**HAI TISEEN PRIMARY HEALTHCARE CENTER  
TAMEEM PROVINCE, IRAQ**

**SUSTAINMENT ASSESSMENT**

**SIGIR PA-08-158  
APRIL 16, 2009**

SUBJECT: Report on the Hai Tiseen Primary Healthcare Center, Kirkuk, Iraq (SIGIR  
Report Number PA-08-158)

Site Photo 4. Hai Tiseen PHC

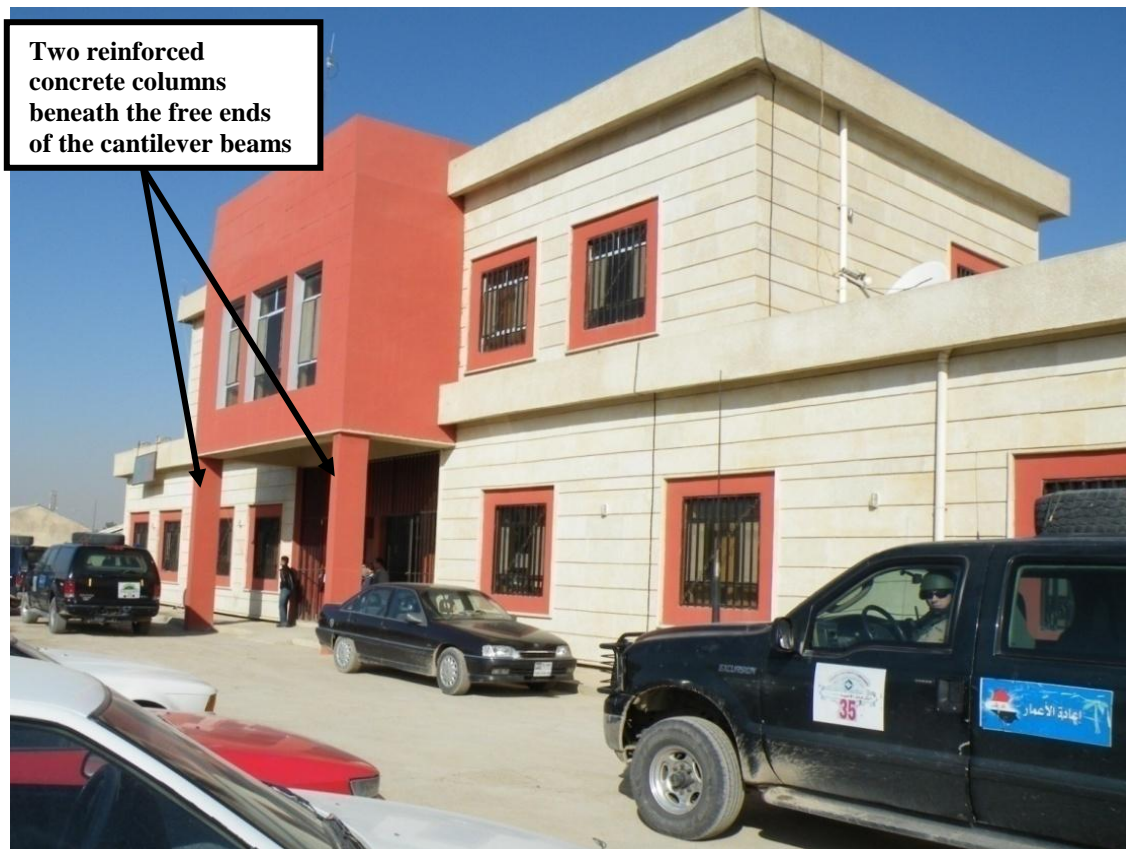
GRD identified a solution for this problem, which consisted of the construction of two reinforced concrete columns beneath the free ends of the cantilever beams (Site Photo 4). According to GRN Kirkuk Area Office representatives, a contract modification added two support columns beneath the cantilever beams over the entrance to the building. The columns were constructed and finished to match the exterior of the building. In addition, the full bearing between the columns and the existing beams was obtained by the placement of non-shrink grout between the top of the concrete columns and the bottom of the existing beam.

Site Photo 5. Two generators providing primary and emergency backup power for the PHC

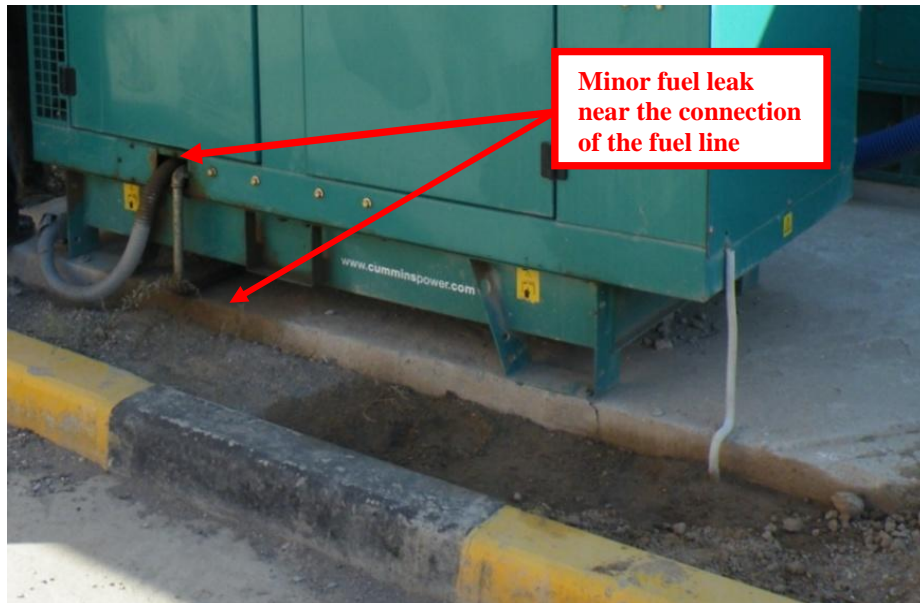
SIGIR noticed evidence of a minor fuel leak from the 500-kV emergency backup generator (Site Photo 6). The minor fuel leak was near the connection of the fuel line to the emergency generator and had spread into the soil in front of the generator. This leak presents a potential fire hazard and the PHC's maintenance staff needs to investigate the cause and repair the problem.

**Site Photo 8. Dental chair and tools**

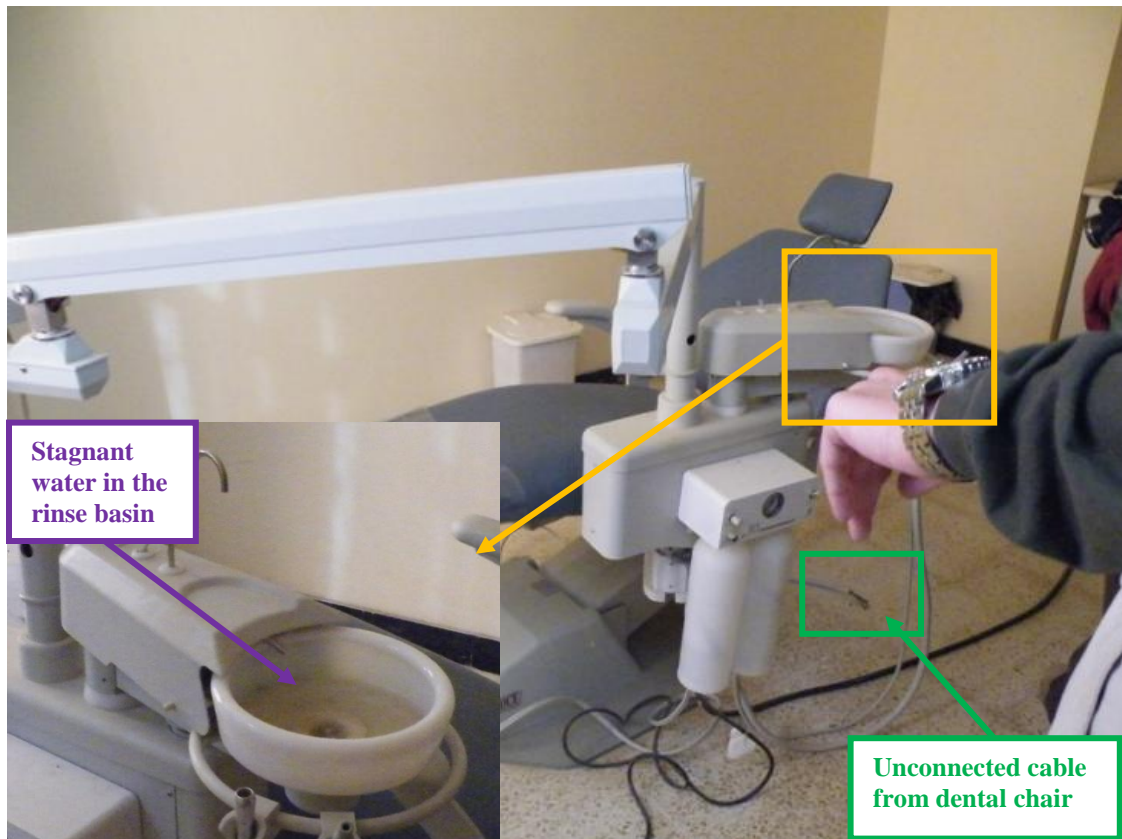
During the site visit, SIGIR observed that the dental chairs were installed. While one dental chair appeared to be in use (Site Photo 8), the second dental chair appeared to have a plugged drain with stagnant water in the rinse basin (Site Photo 9). During the inspection, SIGIR observed a dentist treating a patient while using the working dental chair.

The contractor's installation of the dental chairs, while functional, did not appear to conform to any known plumbing or electric code. The drain for each chair was placed directly into the floor drain with a significant gap between the floor drainpipe and the chair discharge hose. Also, the air lines were not connected for the dental chairs.

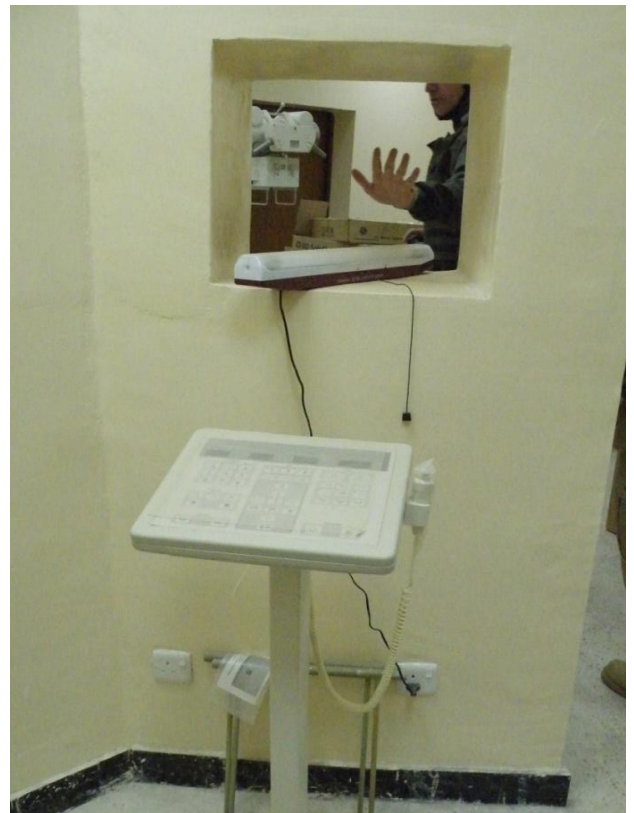
The PHC contract included medical imaging capabilities, specifically an x-ray room and equipment. SIGIR observed that the x-ray equipment was installed (Site Photo 10); however, according to the administrator, the contractor did not verify the equipment was operational. In addition, the administrator stated the facility's staff did not have the technical capability to operate the x-ray equipment; consequently, the facility cannot offer any x-ray services to its patients. Currently, the PHC uses the x-ray room as a medical supply storage room.

Due to the x-ray equipment emitting low levels of radiation, radiation shielding is required to protect the PHC's personnel and patients. The initial design required mass concrete walls with lead lining, lead lined doors, and a leaded glass observation window to provide radiation shielding.

In the 18 July 2007 acceptance letter, one of the noted deficiencies was "x-ray machine," which was to be "installed later." SIGIR noted that the contractor did install the x-ray machine; however, the contract-required installation of a leaded-glass observation window was not installed nor was it noted as a deficiency on the acceptance letter (Site Photo 11). In addition, SIGIR noticed that the contractor installed x-ray room exterior door and darkroom doors appeared to be standard wooden doors. The inspection team could not verify the presence of lead lining on the concrete walls.
